4.0 Architectural Design

4.18 Stakeholder Engagement

Residents Meeting 02 07 March 2024

Proposed Northern Lower Levels: Ziggurat Side

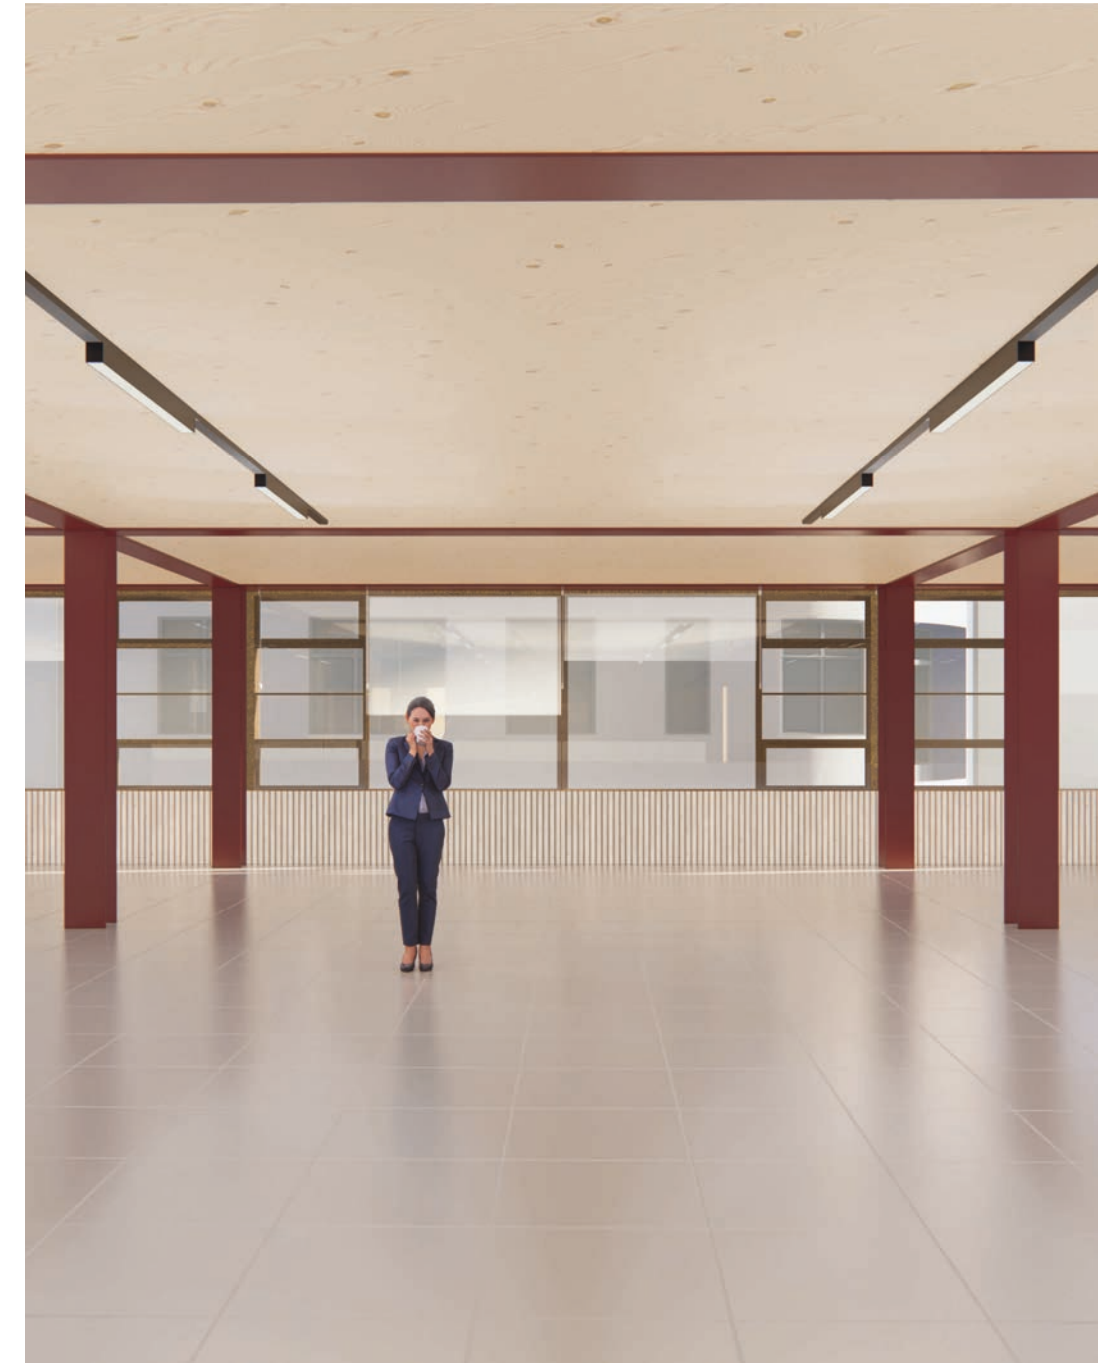
The Ziggurat Building lower floors currently experience overlooking from the existing NCP car park. The car park operates 24/7, which means residents experience overlooking by daily and 'unpredictable' number of visitors, including evenings and weekends.

- 24/7 occupation
- Safety issues on overlooking. Current condition allows for car park visitors to look directly towards Ziggurat apartments. Currently a metal mesh screen does little to obstruct the view from the NCP car park to the Ziggurat building

- Reduced occupation from 24/7 to working hours

Proposed Southern Lower Levels: Da Vinci Side

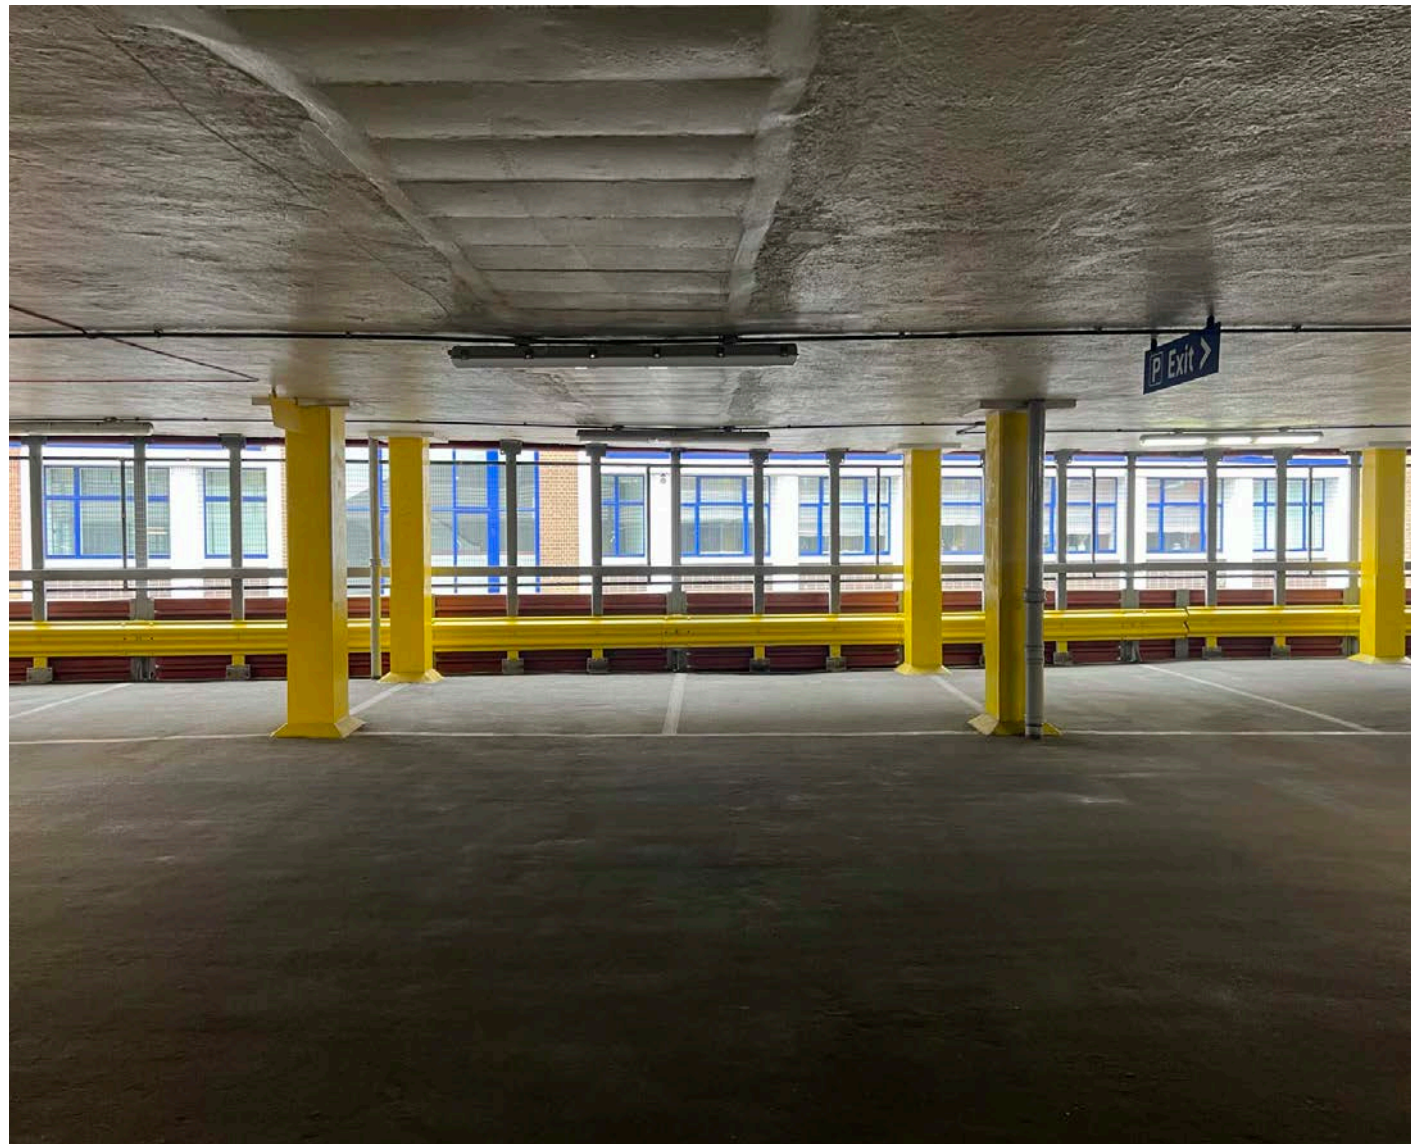
Similarly, the Da Vinci House lower floors experience overlooking from the existing NCP car park.

- 24/7 occupation
- Safety issues on overlooking. Current condition allows for car park visitors to look directly towards Da Vinci apartments. Currently a metal mesh screen does little to obstruct the view from the NCP car park to Da Vinci House.

- Reduced occupation from 24/7 to working hours

1. Existing vs. Proposed views towards Saffron Hill

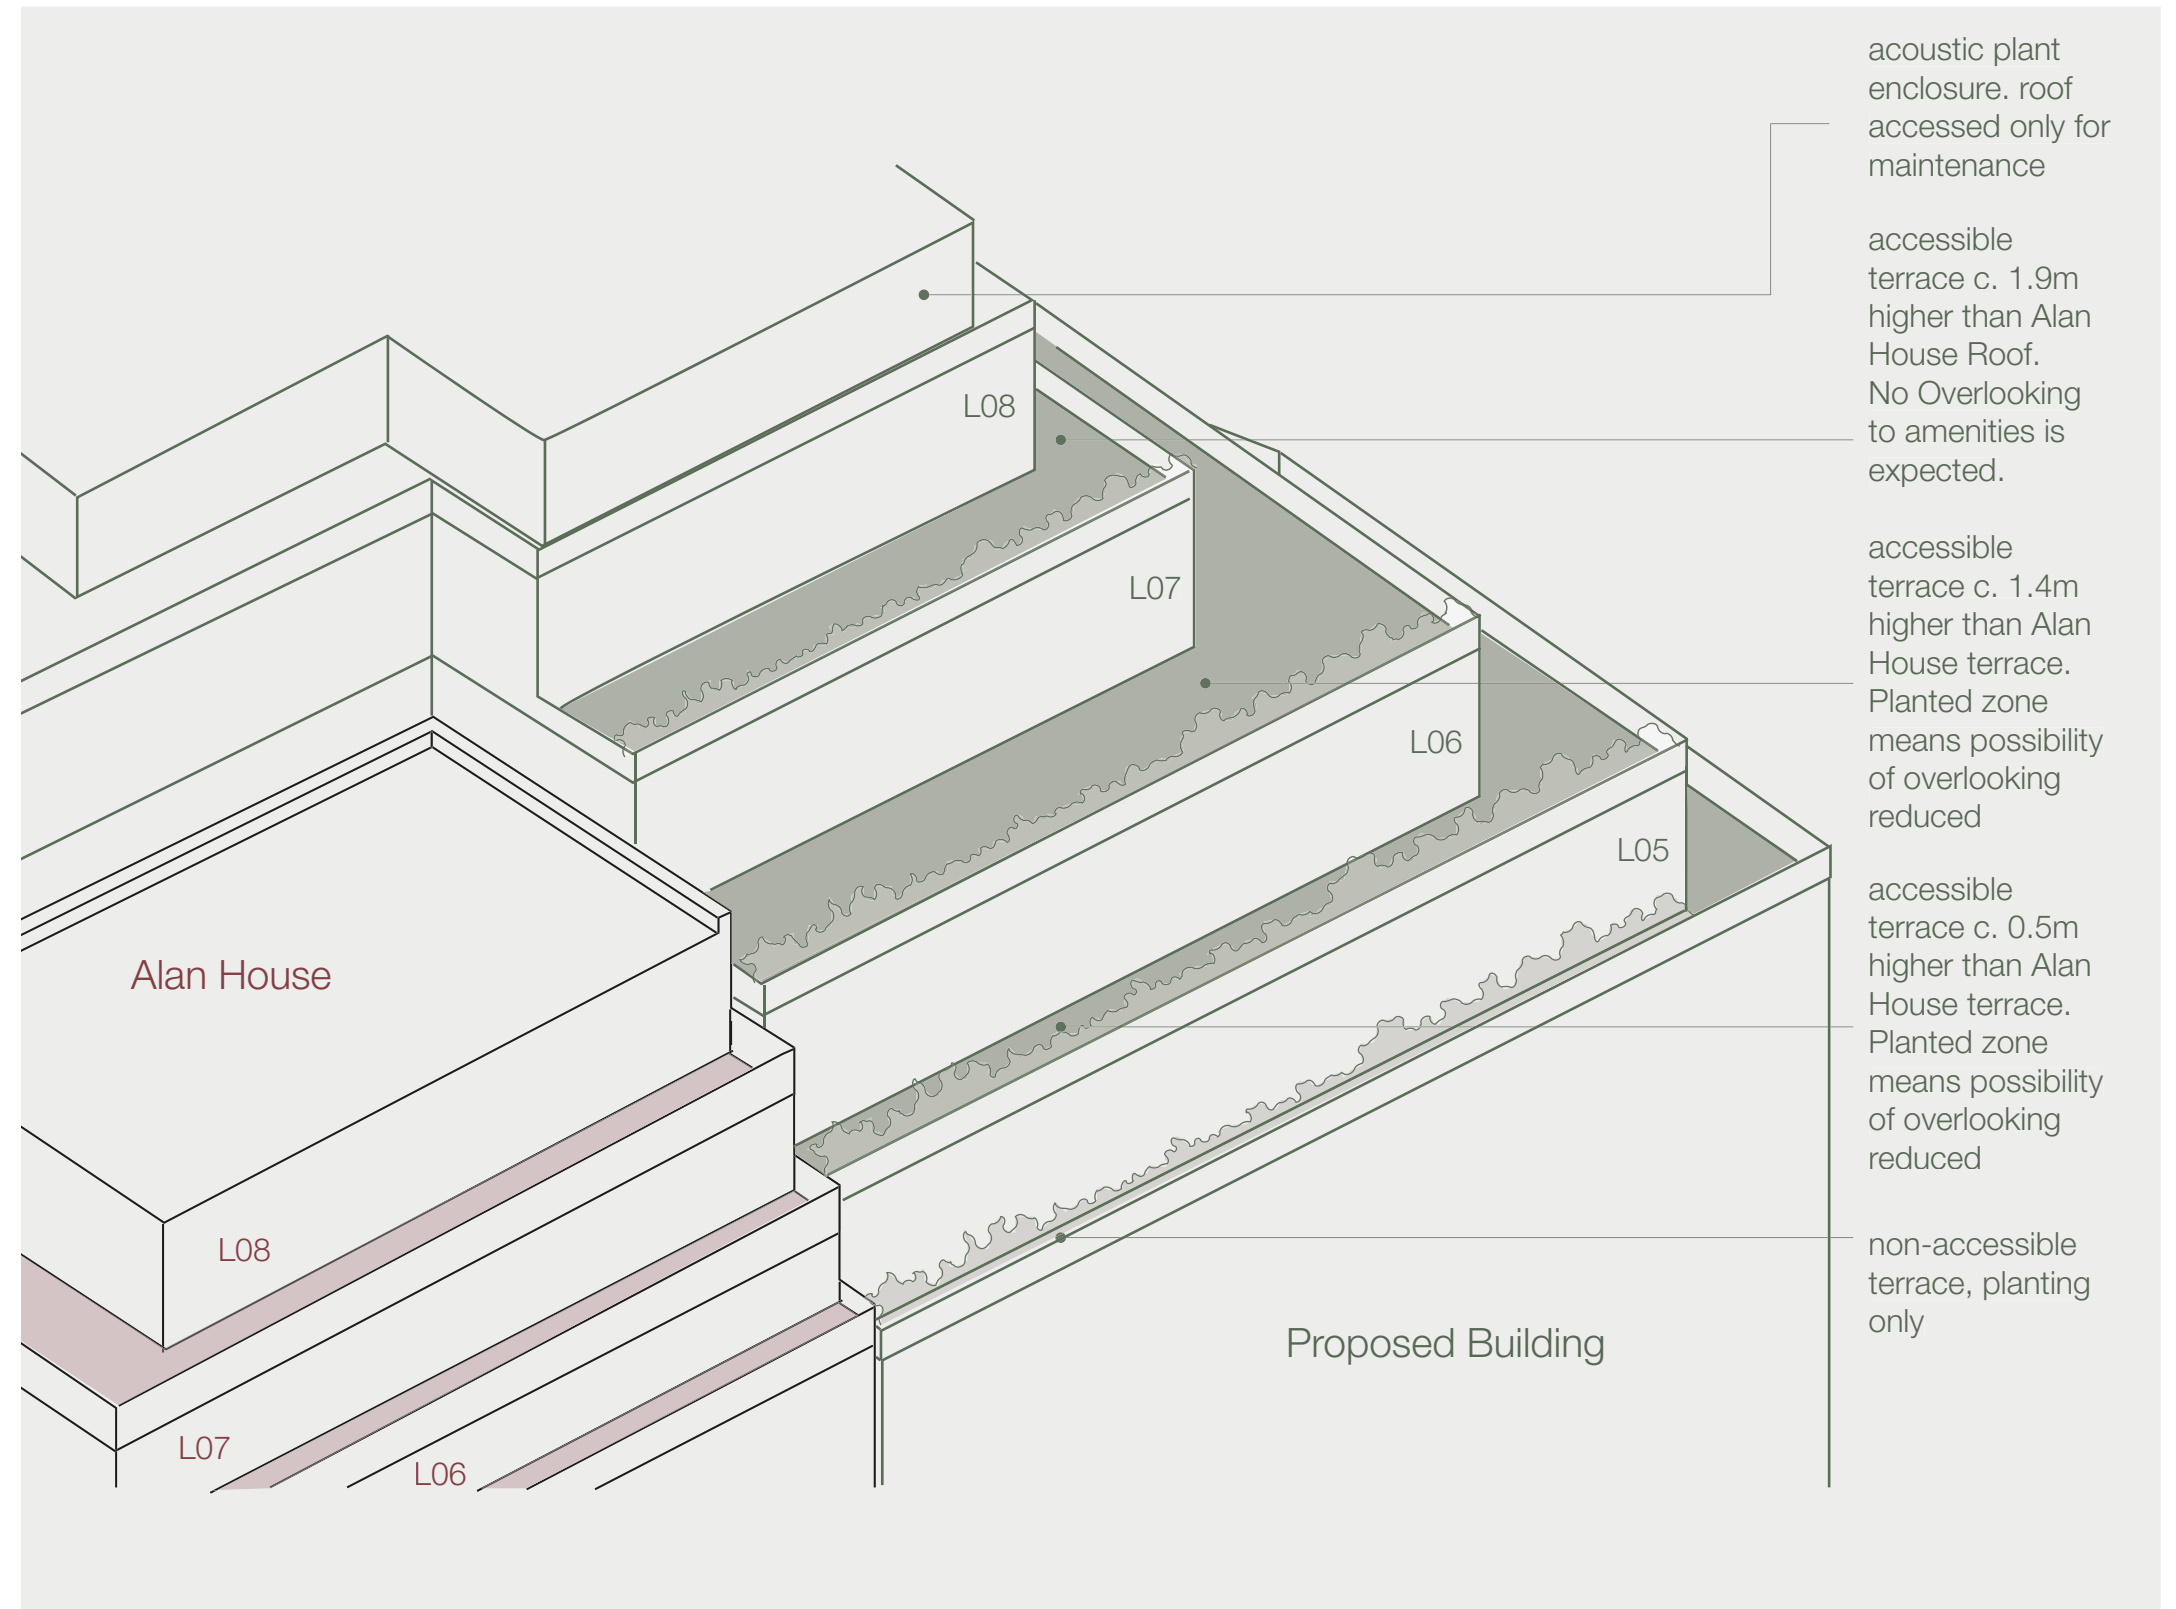
- 1. View required towards Saffron Hill**
- 2. Privacy & Overlooking on West terraces**
- 3. Daylight Sunlight impact to Alan House**

- 1. Existing vs. Proposed view provided**
- 2. Review of relationship of terraces**
- 3. None of the Alan House windows face towards the Site (either facing north onto Saffron Street or west onto Saffron Hill) and therefore Alan House will not experience any daylight/sunlight effects.**
